SS7000[™]

SFA7700[™]

Interposer Issue with SanDisk Lightning SSDs

Table 3. Comparison of Old and New SS7000 Carriers for 2.5" SAS Drives

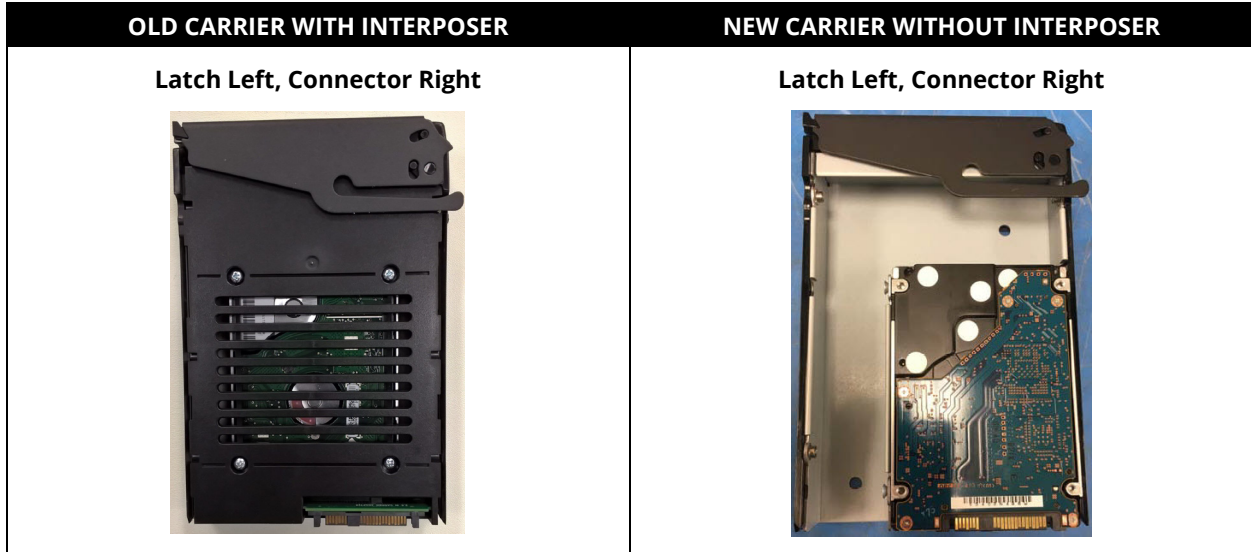
Step 3. Verify that the candidate drive is installed in an old carrier with the 6 Gbps interposer. The two carriers can be identified by visual inspection, as shown in Table 3.

If the candidate SanDisk SSD is mounted in the old carrier, contact DDN Support to arrange carrier replacement.

This issue is resolved by replacing older SS7000 carriers for 2.5-inch drives a new SS7000 carrier. The new carrier uses a mechanical adapter to position any 2.5" form factor SAS drive so that it connects directly to the SS7000 enclosure baseboard. No interposer is required. All new SSD shipments destined for SS7000 enclosures or SFA7700 head enclosures now use the new carrier.
